Product Change Notification

PCN-FDC-1018-2016

Business Unit	Product Line Code	Type of Change	Action	Date of Issue
FDC - Field Device Connectors	ABN	Product Change Notification	Notify Distributors and Field	8/31/2016

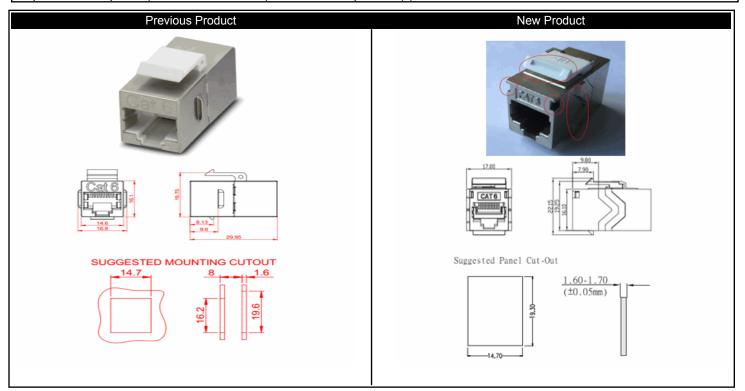
To improve the attached connector, modifications have been made to the latch and side brackets of the RJ45 keystone socket. The data rate and transmission data do not change. The modified latch is now easier to release with a screwdriver. For more details refer to the image and drawings attached.
